Title:                   Advisory Committee on Reactor Safeguards  
                              eVINCI Subcommittee

Date:                    08-21-24

14 During today's meeting, the Subcommittee  
15 will be doing a briefing on the Topical Report and the  
16 staff's Draft Safety Evaluation for the Westinghouse  
17 Principal Design Criteria, or PDC, Topical Report for  
18 the eVinci Microreactor.

# eVinci Microreactor Site Layout

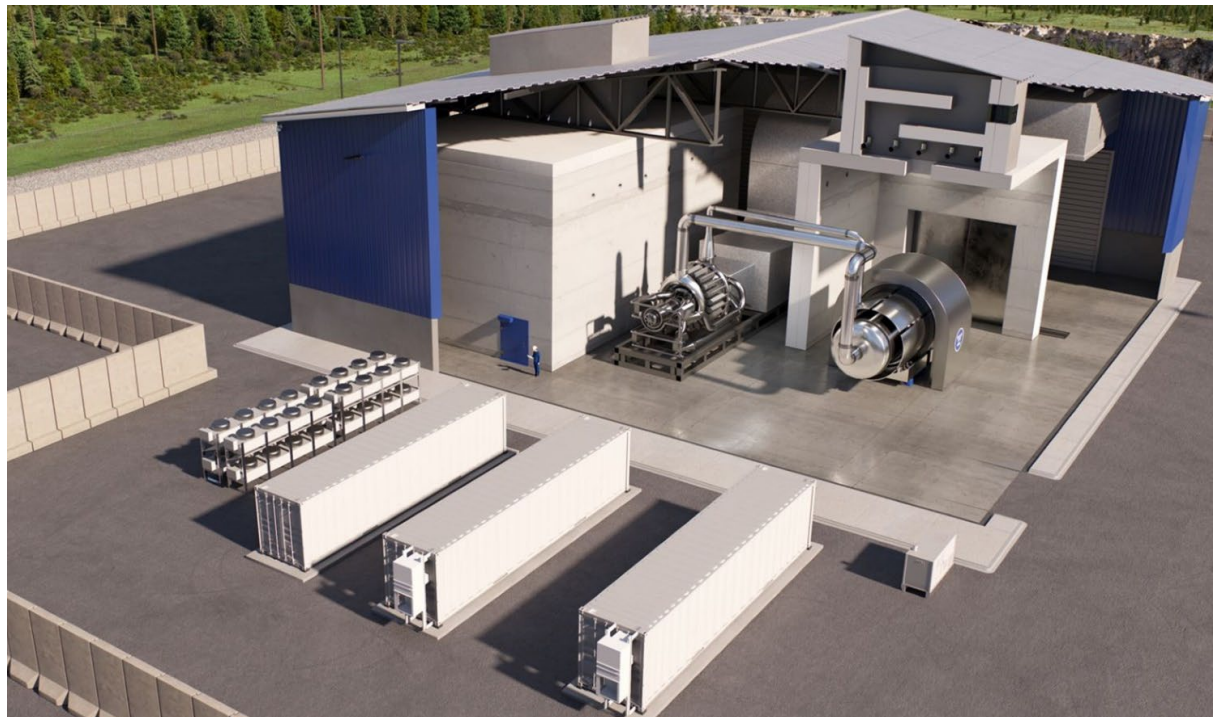
8           CHAIR ROBERTS: Meredith, I just have two  
9 quick questions on radiation levels. It's not clear  
10 from the figure in that slide how much shielding there  
11 is in that blue building to keep the personnel safe in  
12 this reactor.

20           So, in terms of shielding, there's  
21 actually two structures shown there. There is a  
22 concrete structure that provides the majority of the  
23 shielding there, yes.

# eVinci Microreactor Deployment Model

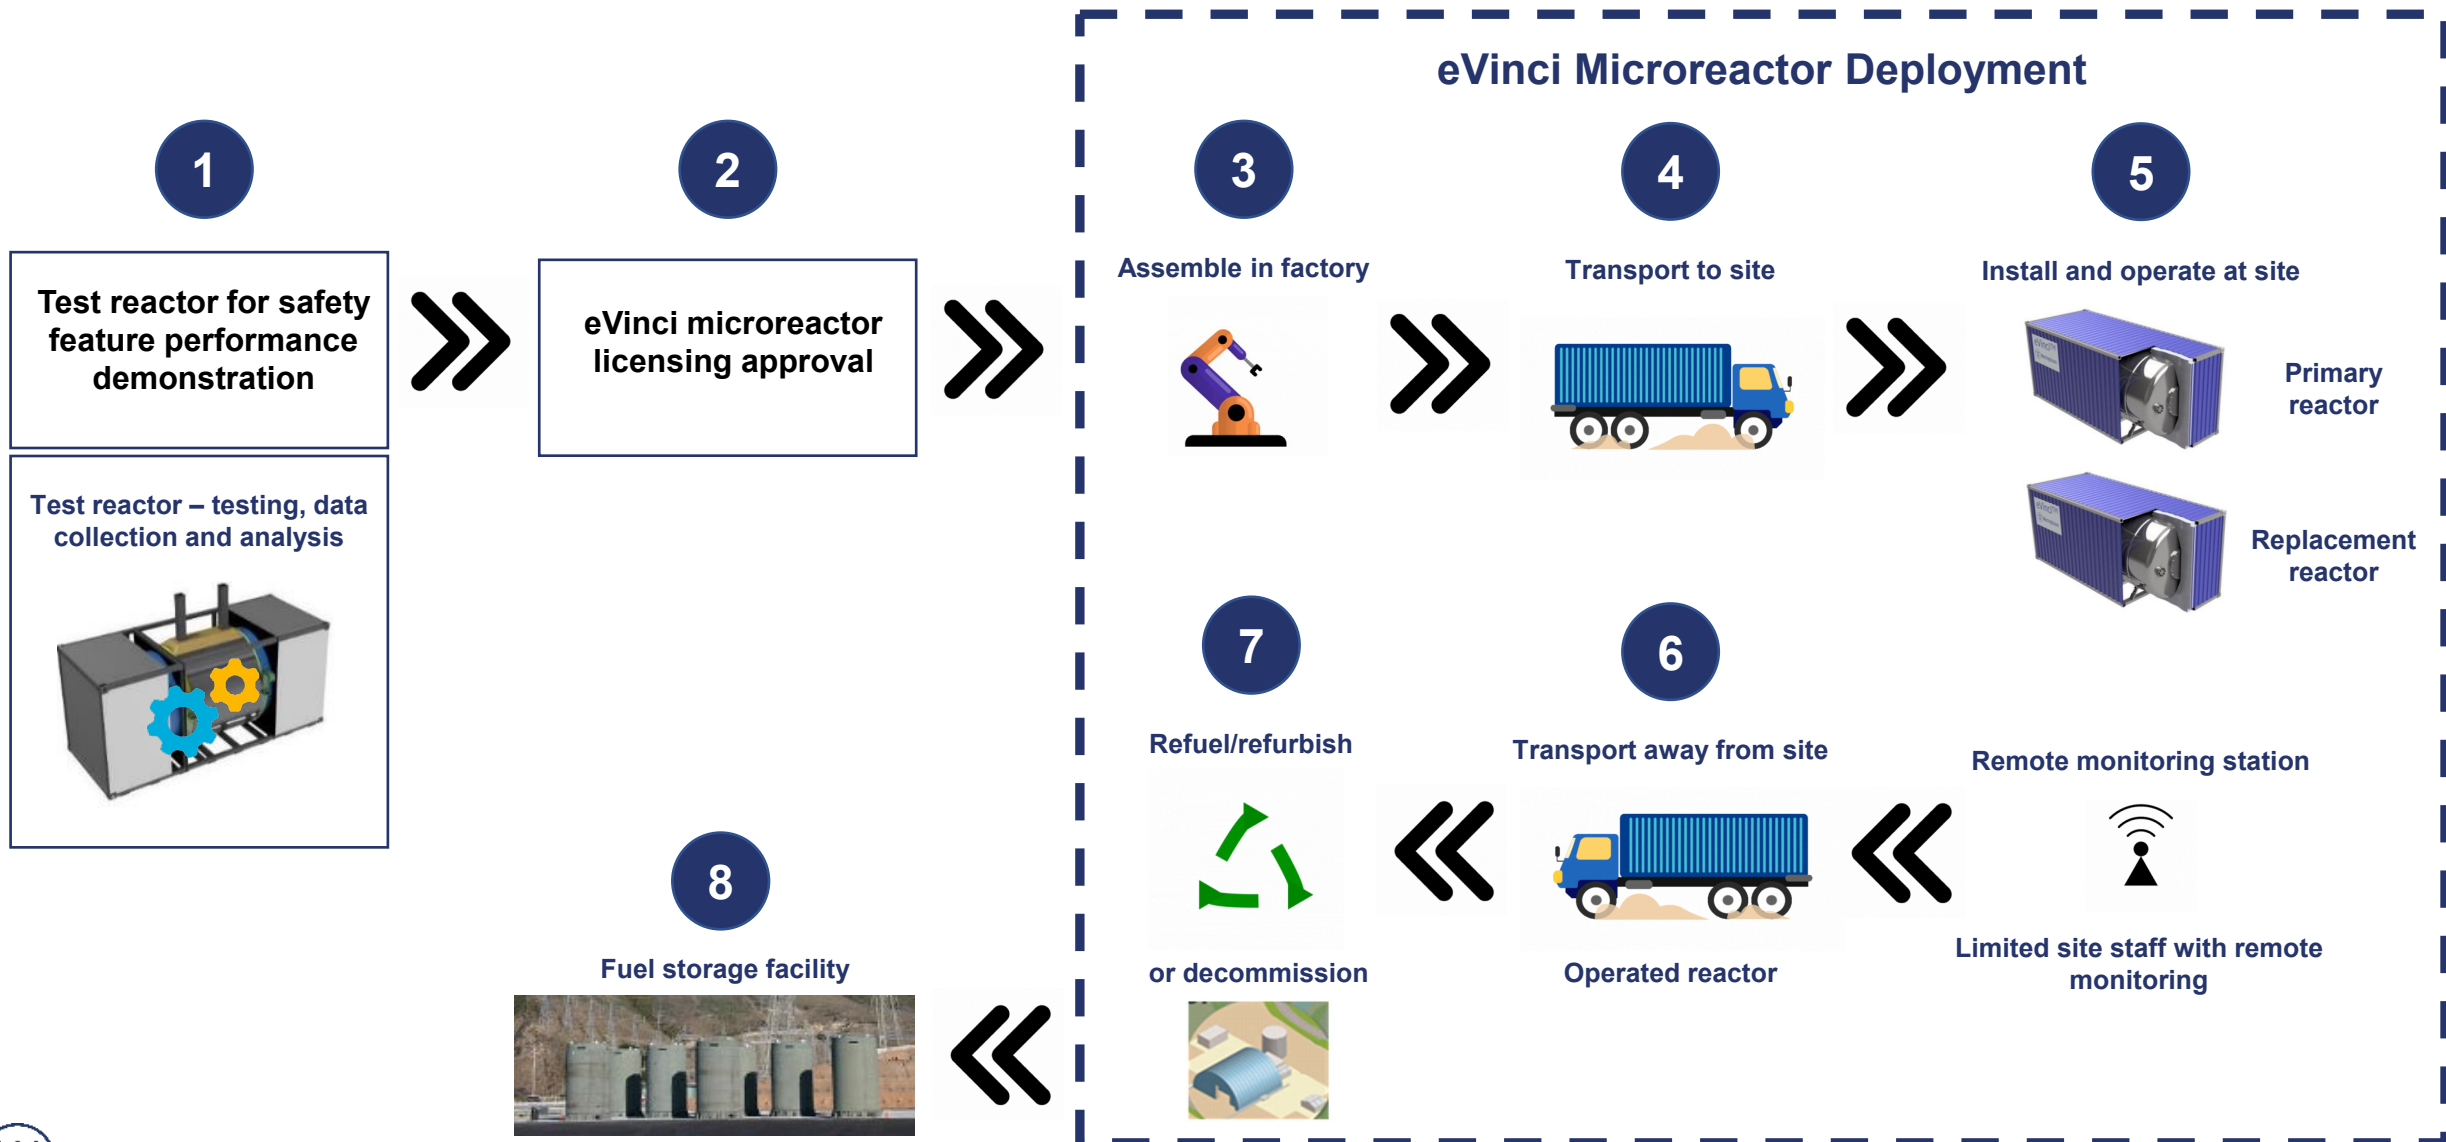
13           It's also not clear on the next slide,  
14 transport away from site, what kind of delays you need  
15 before you can transport safely on the road.

6 So, the question on transportation, we  
7 will be certifying a reactor transportation cask for  
8 the reactor module, both to ship onsite with the fresh  
9 fuel and ship away with the spent fuel. And we will  
10 make sure that it meets the Part 71 regulations for  
11 fissile packages.

12 So, that cool-down period, while we're  
13 still developing what that would actually look like,  
14 it will be to ensure that we do meet the Part 71  
15 regulations to ship it offsite.
